**CITY PLAN COMMISSION****THURSDAY, APRIL 9, 2026****FILE NUMBER:** PLAT-26-000089**SENIOR PLANNER:** Sharmila Shrestha**LOCATION:** Kirby Street, south of Homer Street**DATE FILED:** March 12, 2026**ZONING:** MF-2(A)**CITY COUNCIL DISTRICT:** 2**SIZE OF REQUEST:** 0.0907-acres**APPLICANT/OWNER:** Davit Barseghyan

**REQUEST:** An application to create one 1,489 square-foot lot and one 2,463-square-foot lot from a 0.0907-acre tract of land in City Block 12/2003 on property located on Kirby Street, south of Homer Street.

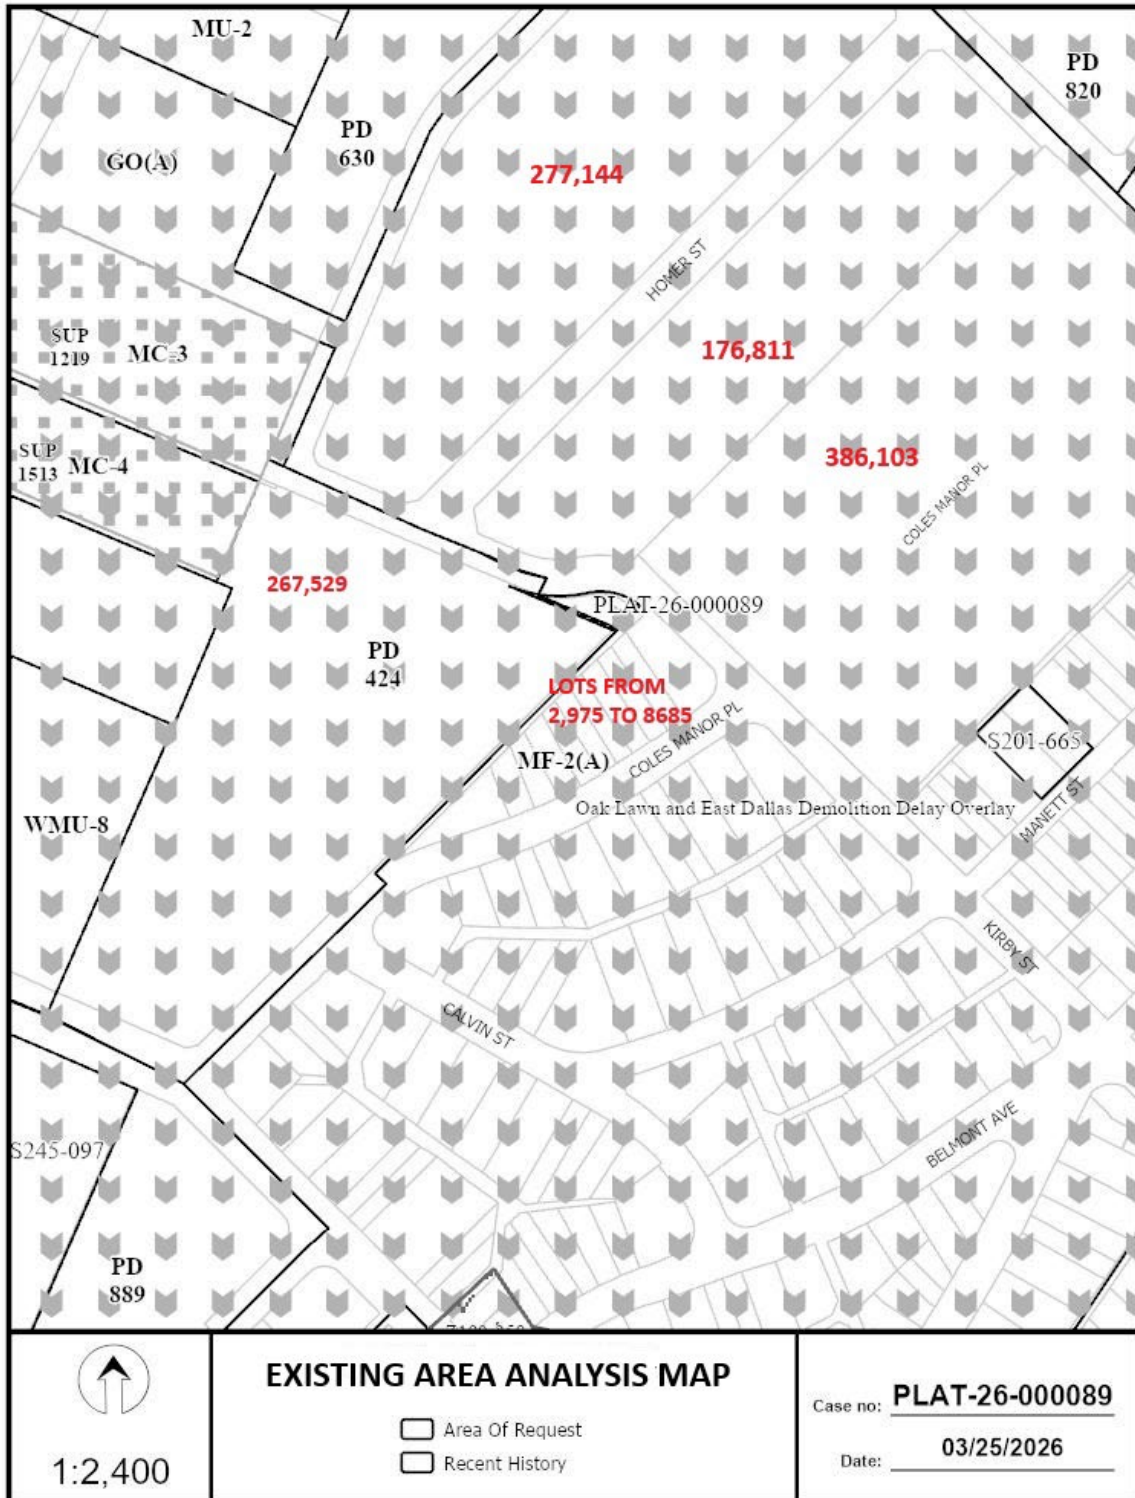
14. On the final plat, dedicate 7.5 feet of right-of-way (via fee simple) from the established center line of Alley. *Section 51A 8.602(c)*
15. On the final plat, dedicate a 15-foot by 15-foot Alley Sight Easement at the intersection of Kirby Steet & the alley. *Section 51A-8.602(e)*

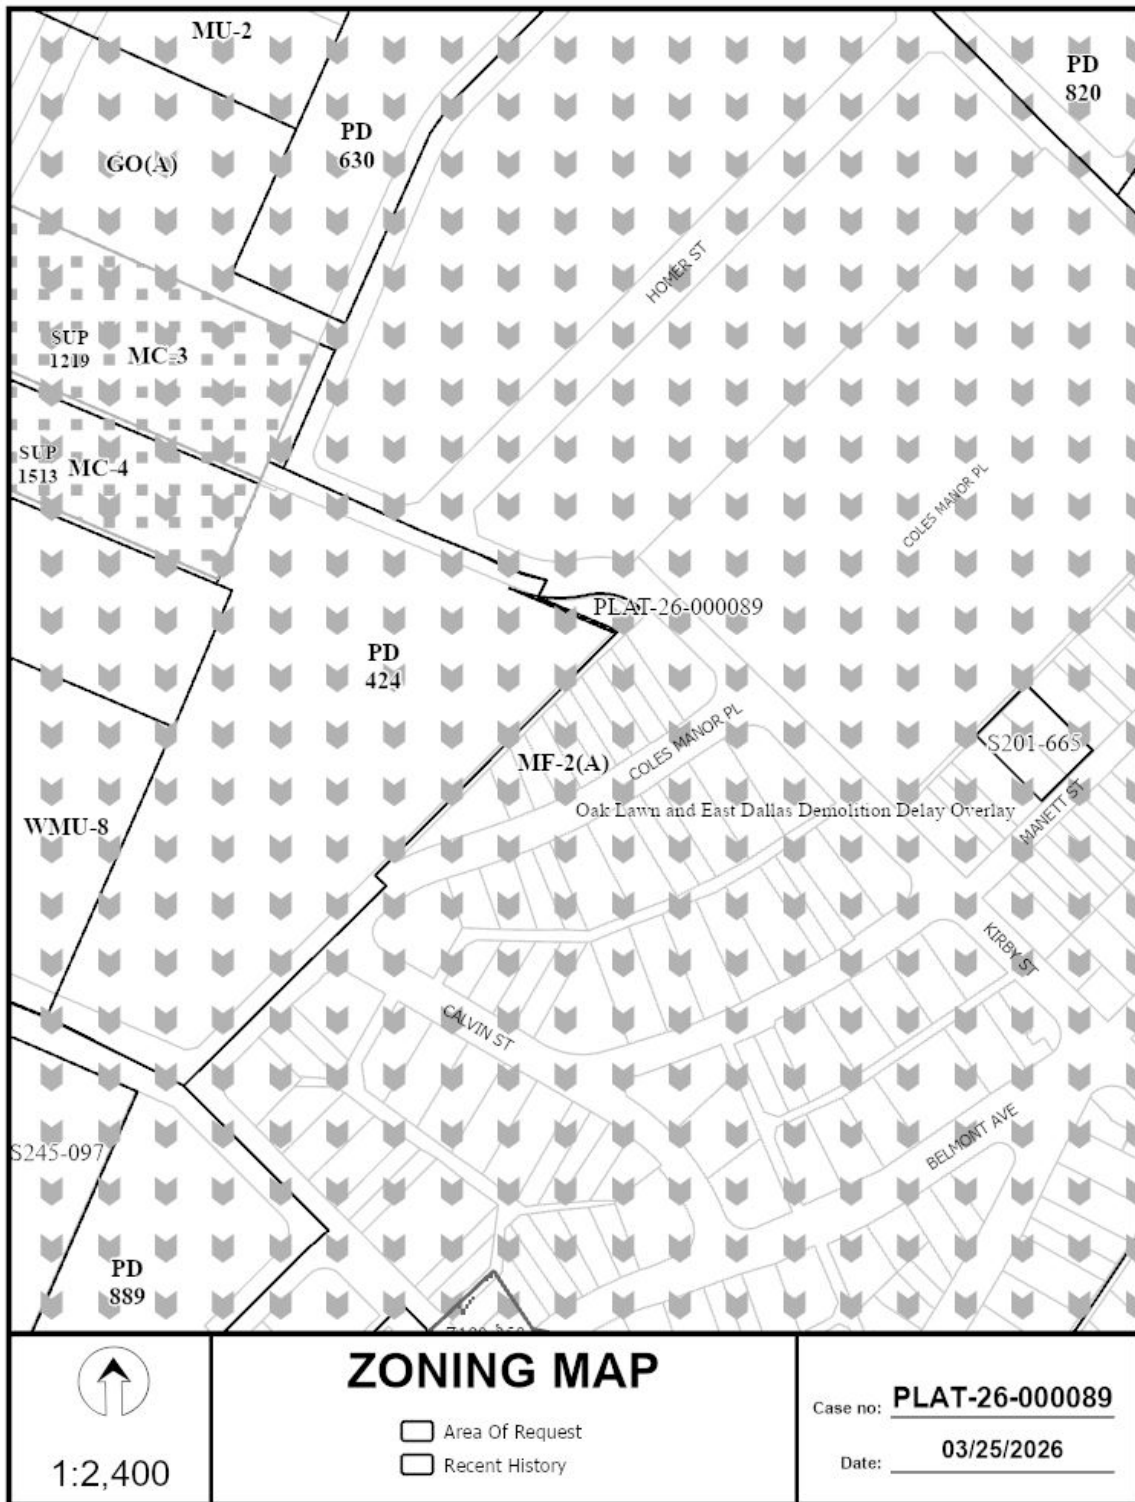
16. Prior to final plat, submit a completed final plat checklist and all supporting documents.
17. On the final plat, show the correct recording information for the subject property.
18. On the final plat, show how all adjoining right-of-way was created. Section 51A-8.403(a)(1)(A)(xxii).
19. On the final plat, show recording information on all existing easements within 150 feet of the property.
20. On the final plat, show all additions or tracts of land within 150 feet of the property with recording information. Platting Guidelines.
21. On the final plat, chose a new or different plat name.

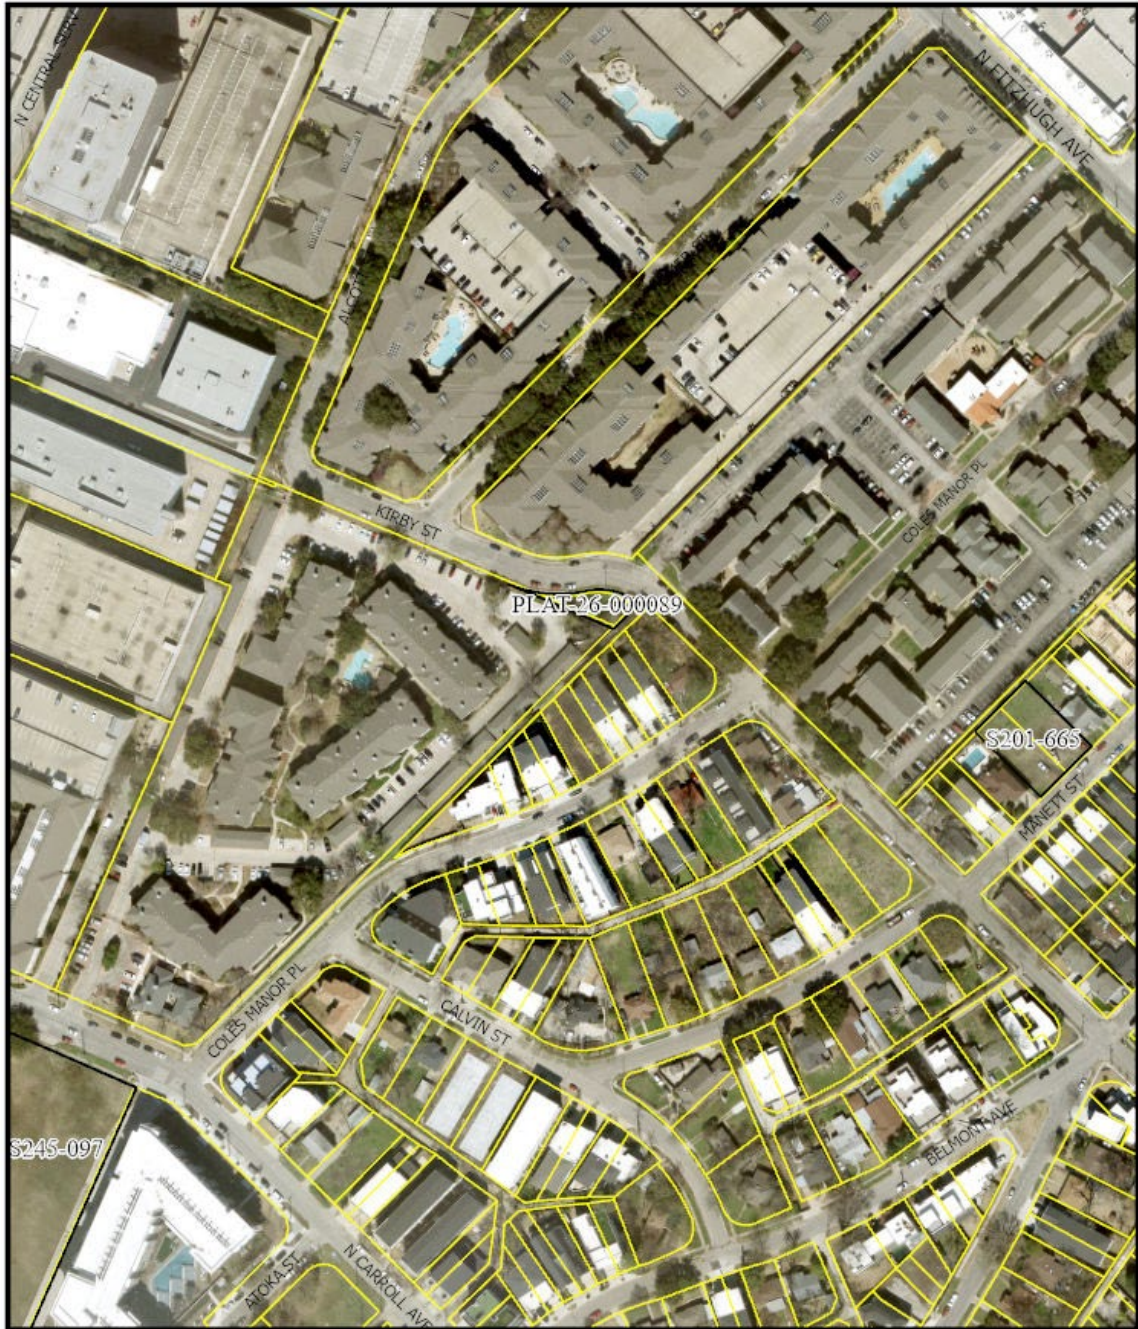
22. A tree survey is required. Please show all trees on the site 8" or larger labeled size and species.
23. On the final plat, add "Homer Street" to plat drawing.
24. On the final plat, add "Coles Manor Place" to plat drawing.
25. On the final plat, identify the property as Lots 4 & 5 (SE lot) in City Block 12/2003.
